Change of locking system to LLFS 7.50/90

the below listed articles will be supplied in a modified revision. Please pass this product information on to your employees and, if needed, to your customers. All modifications are performed for reasons of product improvements.

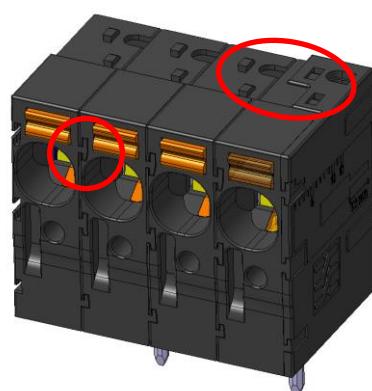
The locking structure on the cover plate and housing will be changed for LLFS 90° version.

Based on this change the cover force will be increased and quality improvement can be achieved. There is no influence on the overall dimension or electrical data in the data sheet.
